### STAFF RECOMMENDATION

2212 Grantland Avenue

April 20, 2016

**Application:** Demolition; New construction—infill and outbuilding/detached accessory dwelling unit

SITE PLAN

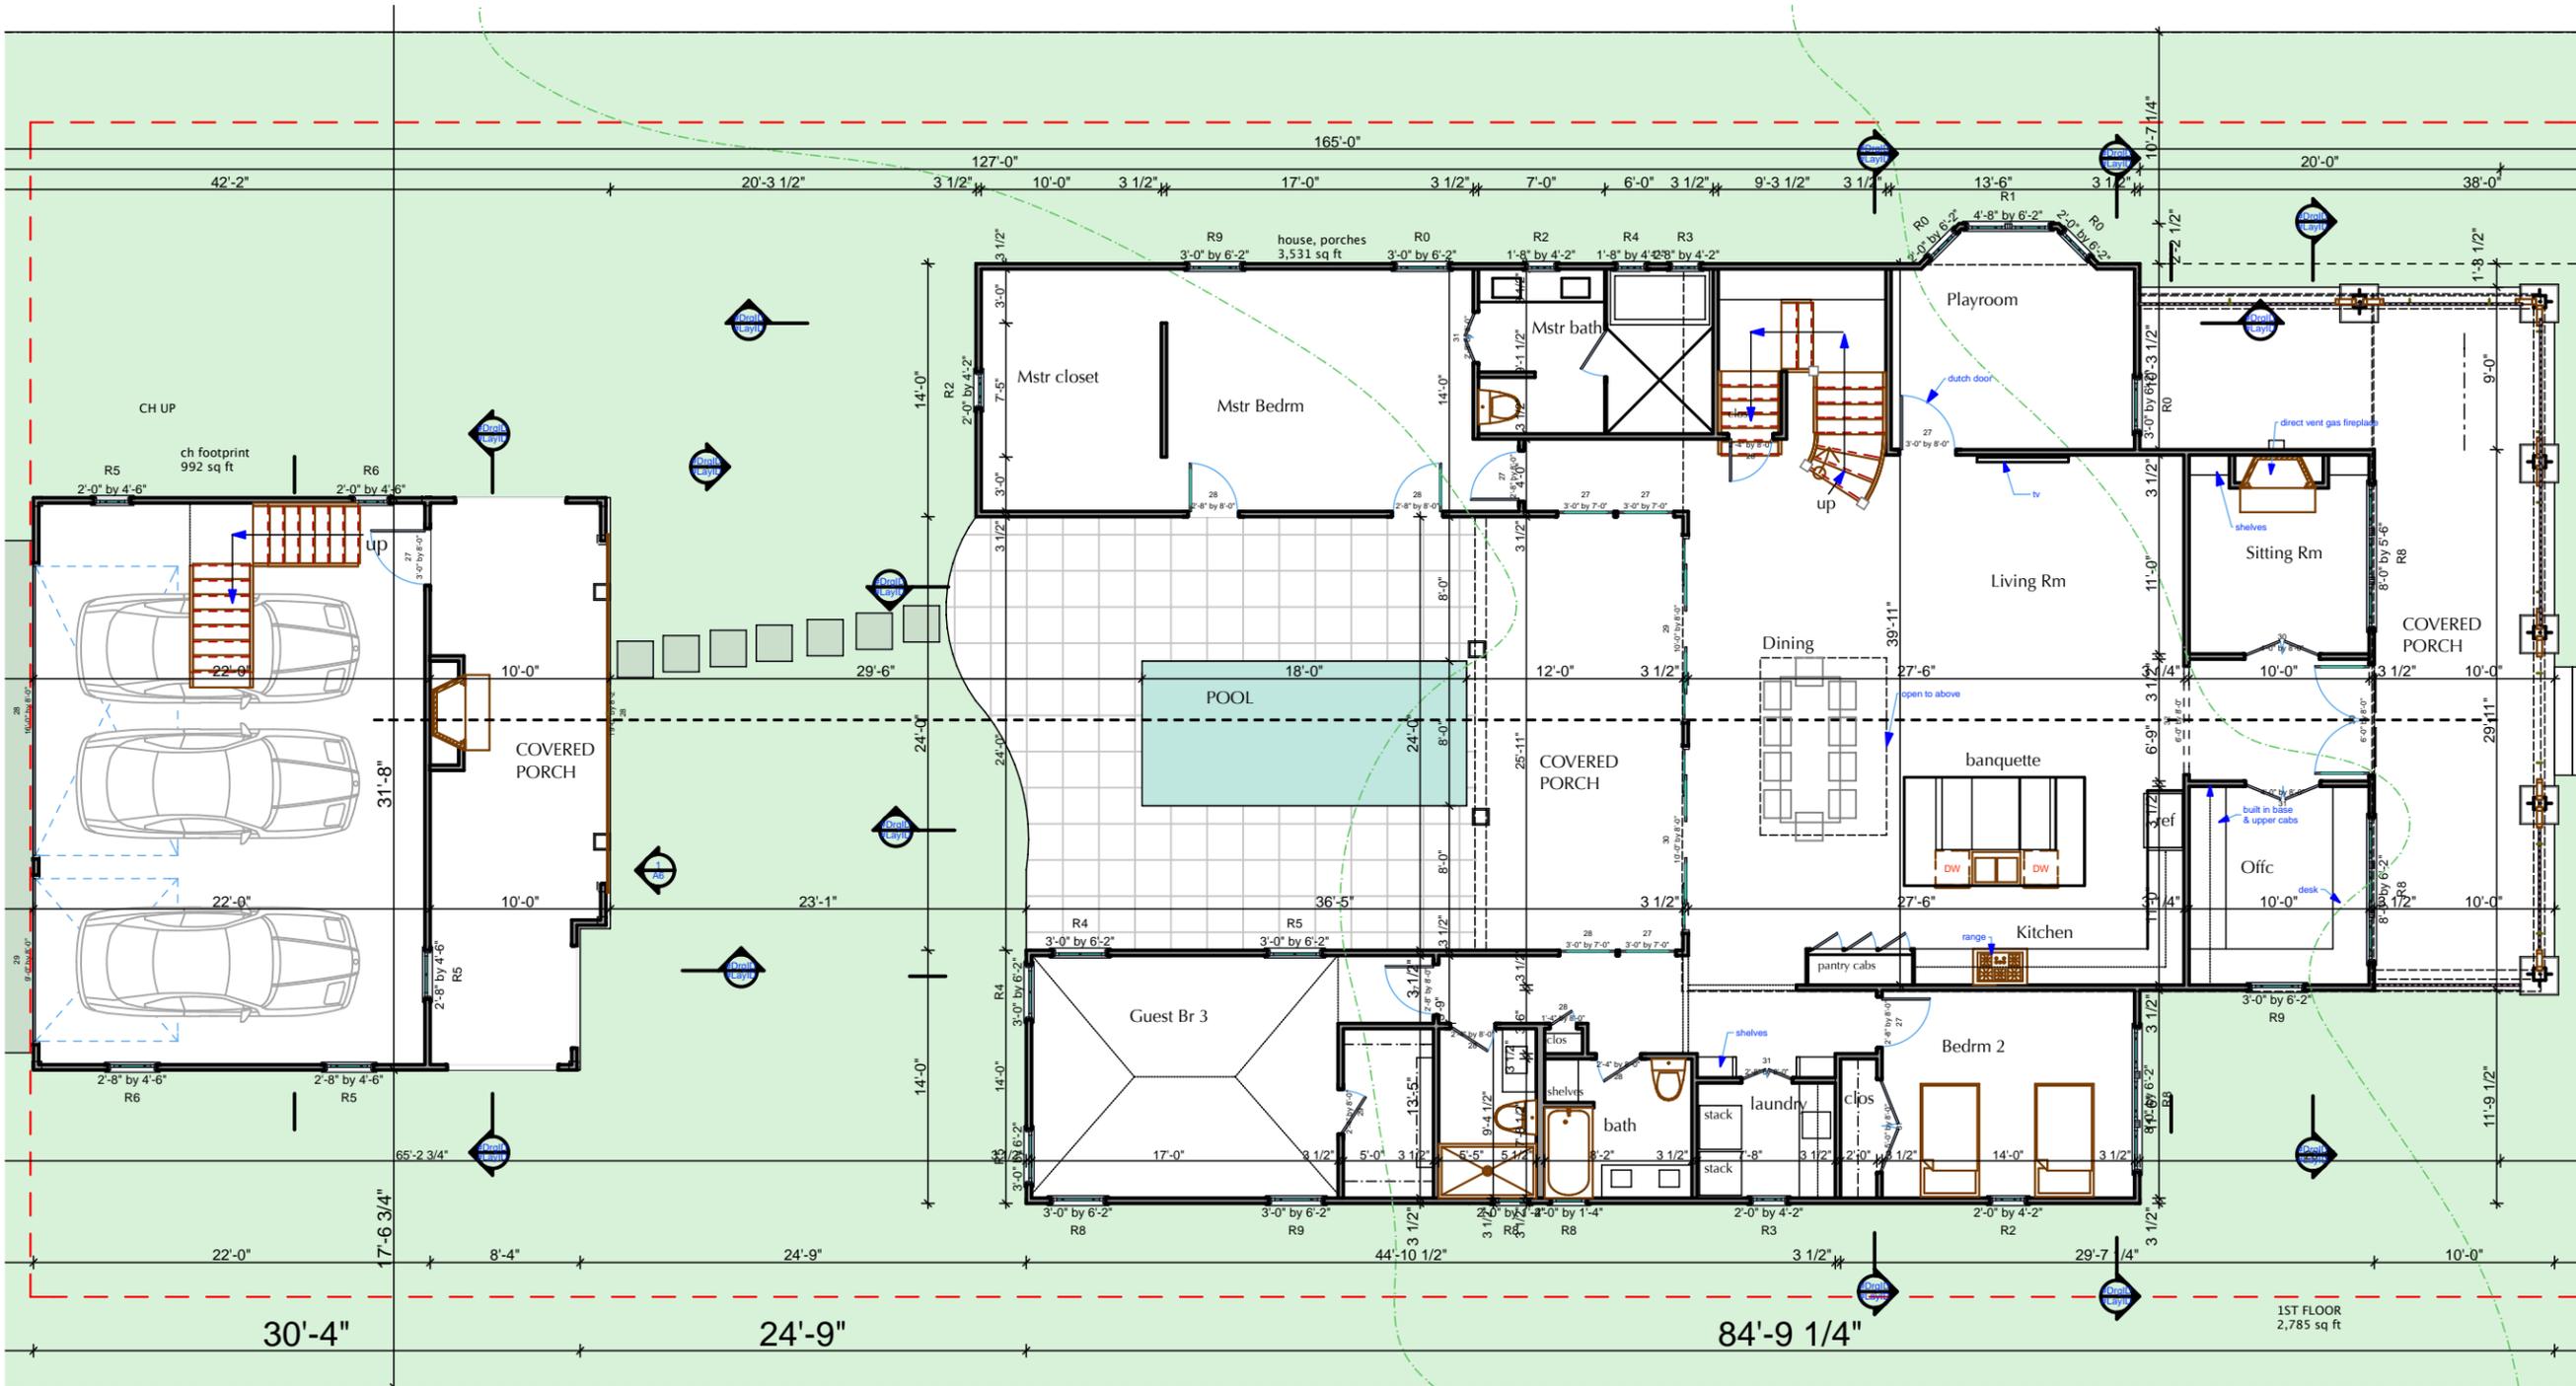
Setback and Rhythm of Spacing: The new infill meets the base zoning minimum setback requirements. The structure will be approximately eight feet (8') from the left side of the property and five feet (5') from the side property lines at its widest, and it will be approximately fifty-eight feet (58') from the rear property line. The front edge of the infill will be located fifteen feet (15') from the front property line, which is the average of the two adjacent historic structures. Staff finds that the project's setback and rhythm of spacing meet section III.B.2.c of the design guidelines.

The new outbuilding requires a rear setback determination. When an outbuilding has a footprint greater than seven hundred square feet (700 sq. ft.) in an area with R6 base zoning, the bulk zoning regulations require that the structure be located twenty feet (20') from the rear property line and five feet (5') from the side property lines. In this instance, the structure is located more than five feet (5') from the side property lines but only ten feet (10') from the rear property line. Staff finds that the proposed rear setback is appropriate because outbuildings historically were built very close to the rear of a property. A ten foot (10') rear setback is more historically appropriate than a twenty foot (20') rear setback. In addition, the ten foot (10') rear setback allows for more space between the primary structure and the DADU. Staff recommends approval of the setback determination.

1ST FLOOR PLAN

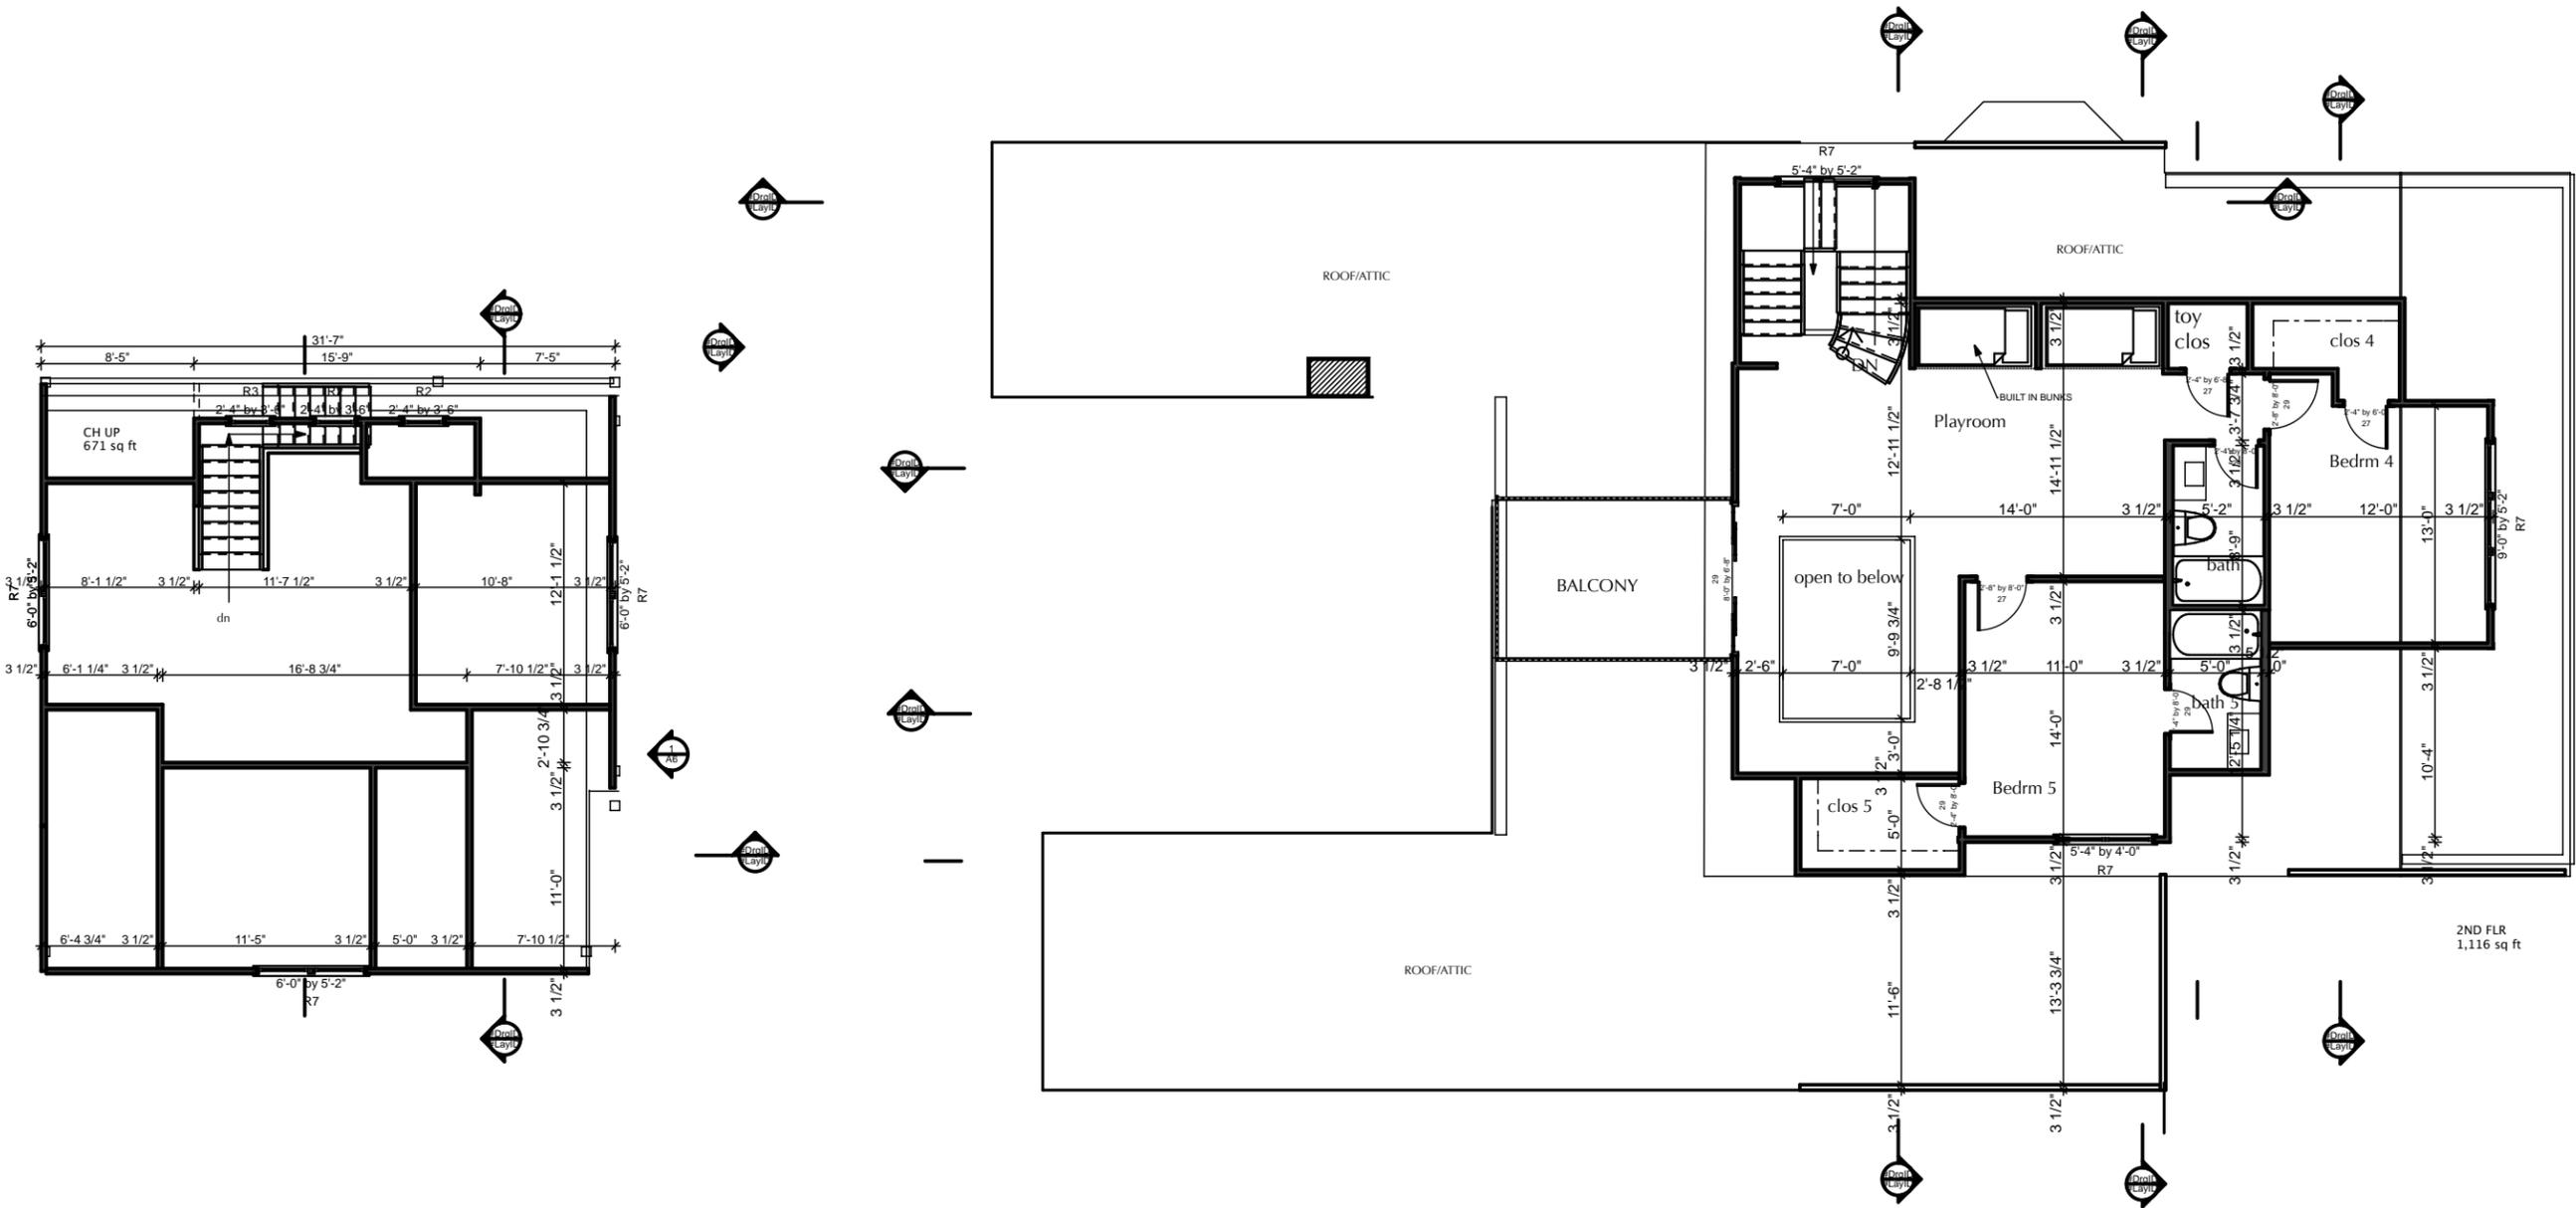
The building will have a primary mass that is thirty-nine feet (39') wide, with a wing on the left side increasing the body of the house to fifty-two feet (52'). The wing will begin twenty-three feet (23') back from the front edge of the building. A bay window on the

right will extend an additional two feet (2'), for a total width of fifty-four feet (54'). The widths of historic houses on Grantland Avenue range between thirty feet (30') and thirty-nine feet (39'). Although this building will be wider than its immediate neighbors, this lot is fifteen feet (15') wider than the typical lot on the Street. Because the lot is wider, and because the point where it begins to widen is set back considerably from the front of the building, Staff finds the greater width to be appropriate.
